Project Trillium Development  
**The Terraces at Highgate**  
 1514 & 1520 Cedar Hill Cross Road & 3801 & 3811 Cedar Hill Road  
 Victoria, BC

Sheet Title  
**LANDSCAPE PLAN**

Drawn By: **AJS** Checked: **CAR**  
 Project Number: [blank] Scale: **1:150**  
 Revision: **R3** Sheet Number: **L1**  
**JUN 21 2021**  
 PLANNING DEPT. DISTRICT OF SAANICH

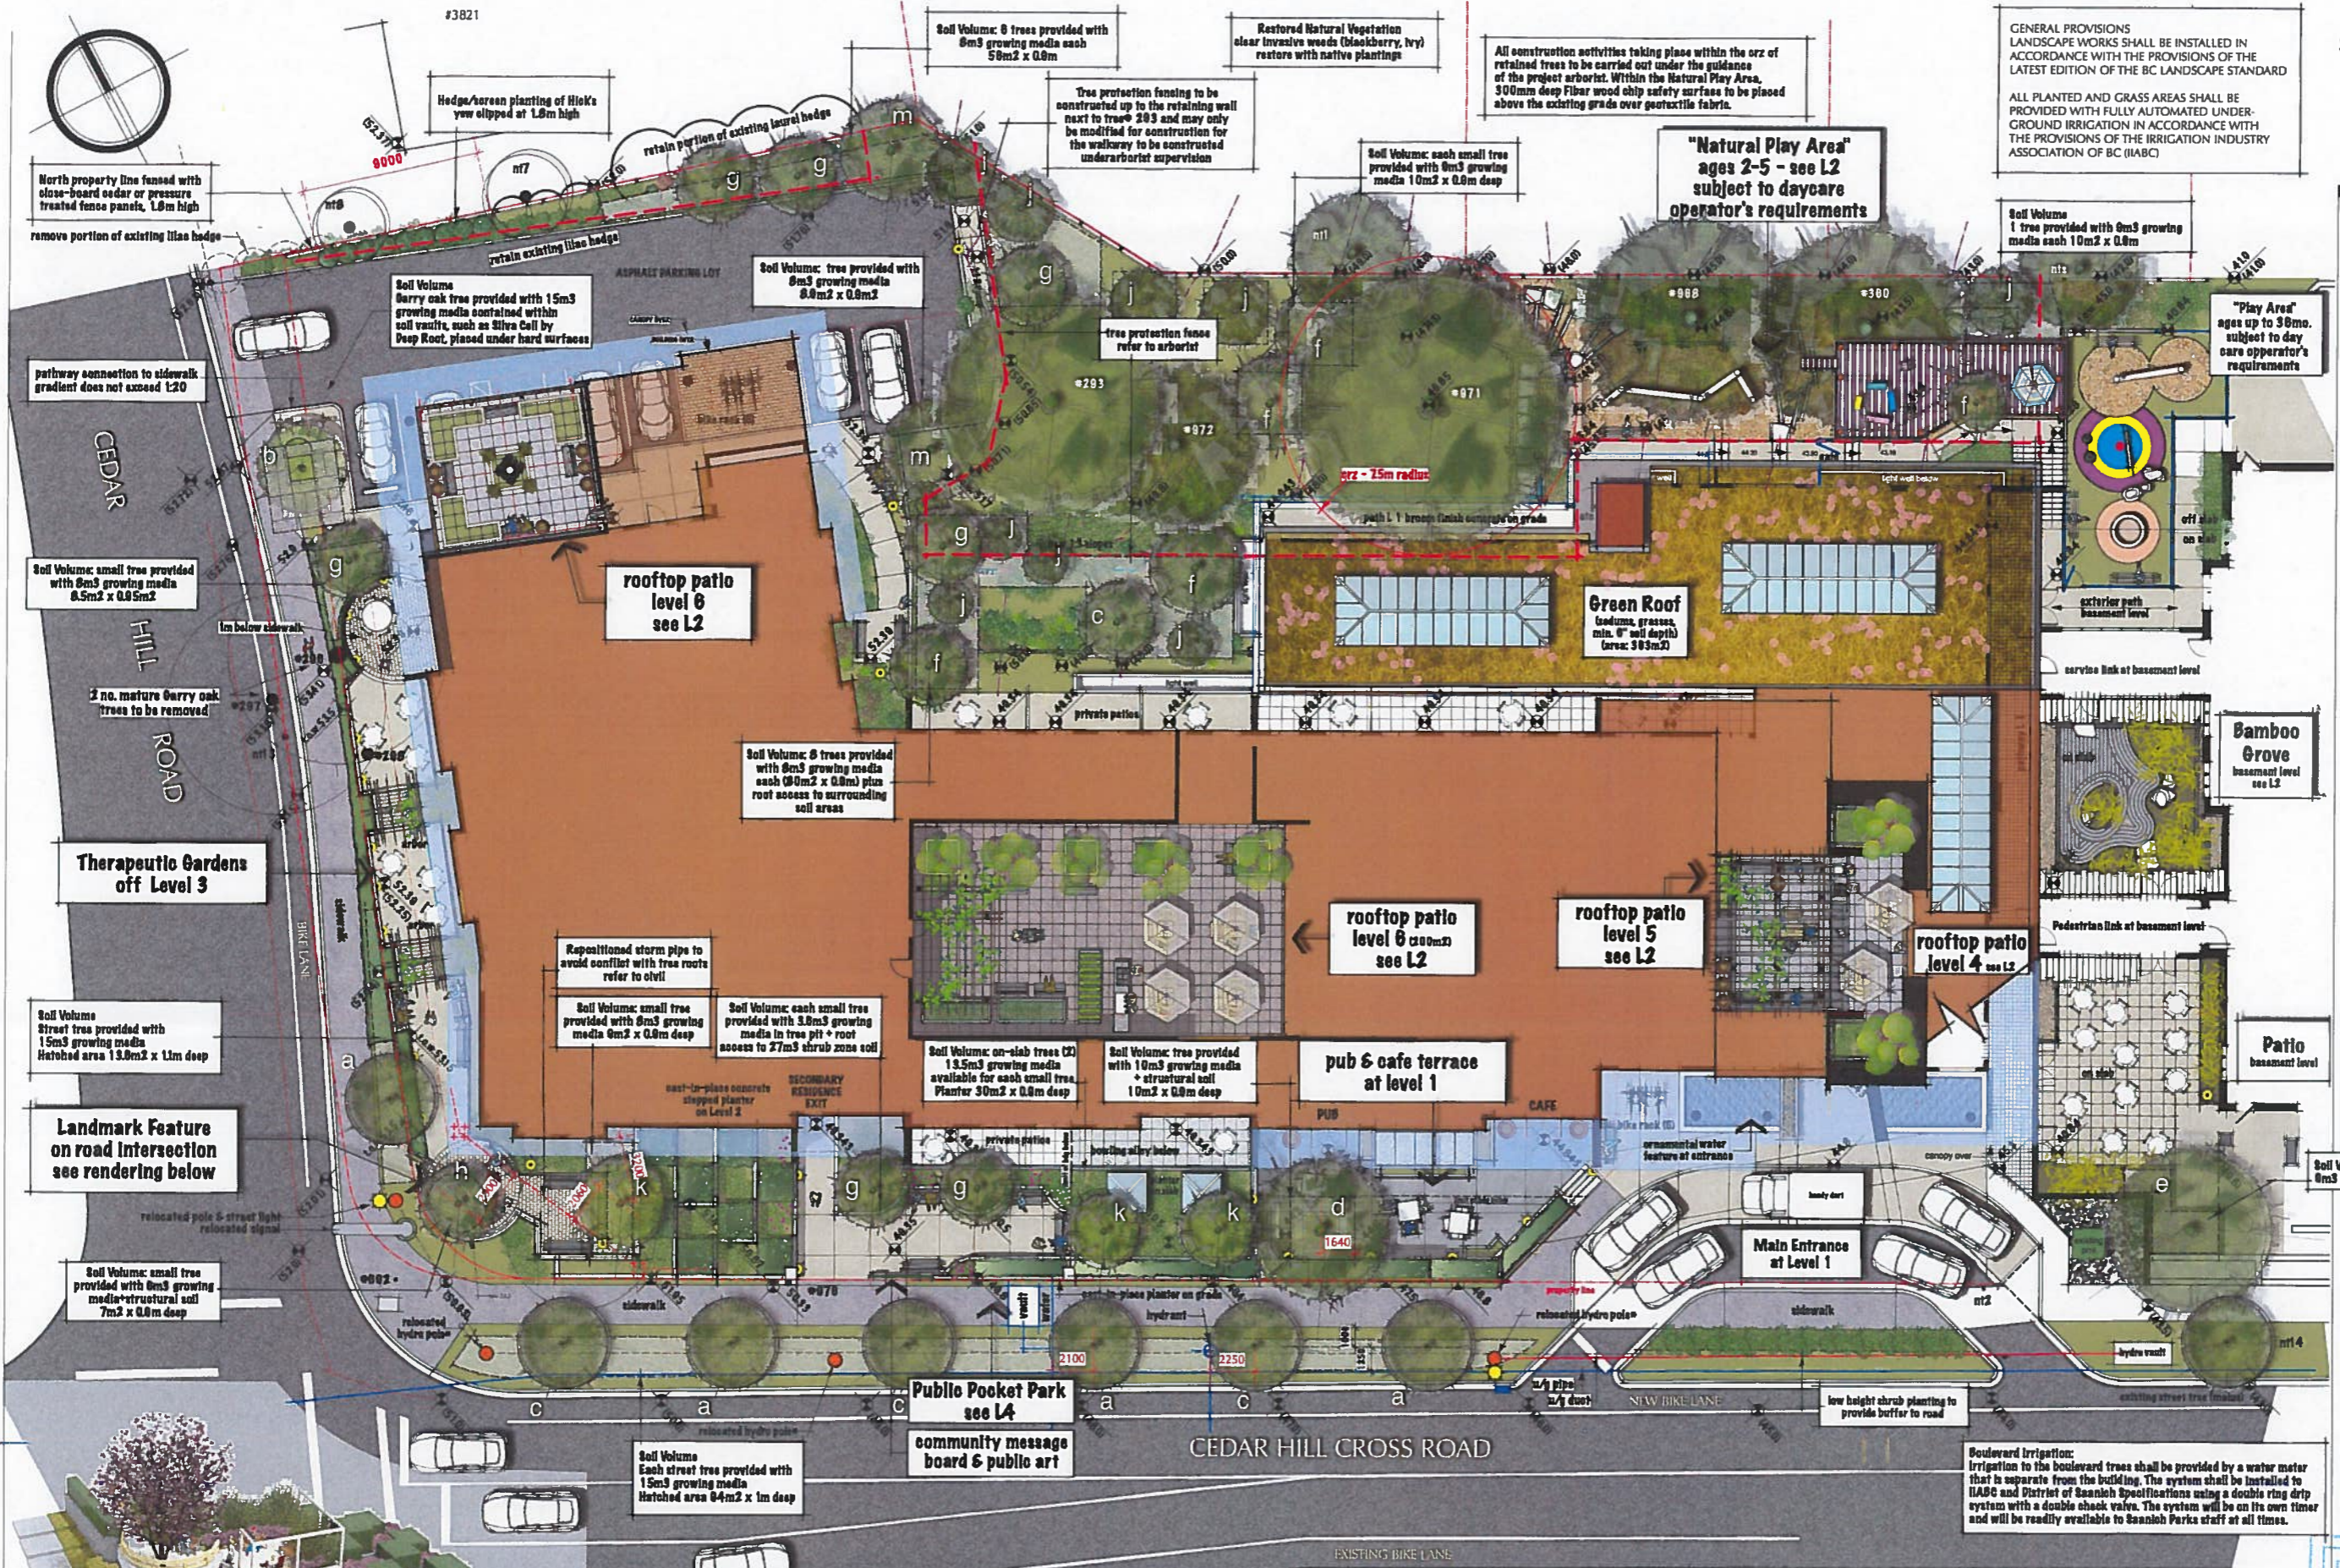
Revision No.	Description	Date
3	a. Soil Vault added to boulevard tree & tree species revised to Garry oak b. Tree tag #s added to existing boulevard trees to be removed c. Pathway connection to Cedar Hill Rd added d. Bike rack (8 bikes) added to main entrance court e. Tree barrier alignment adjusted for trees # 971 f. Off-site tree NT13 (for removal) identified g. Pocket Park added with Community Message Board h. Revised building extends over north parking lot, landscape plan adjusted to suit i. Exit pathway and exterior stairs added, NE bdg play area footprint adjusted j. Architectural skylights added, soil volumes for 2 trees recalculated k. Revised roof plan - 4th, 5th & 6th floor patios redesigned, green roof area reduced l. Tag# NT14 corrected m. New small tree added	11 June 2021
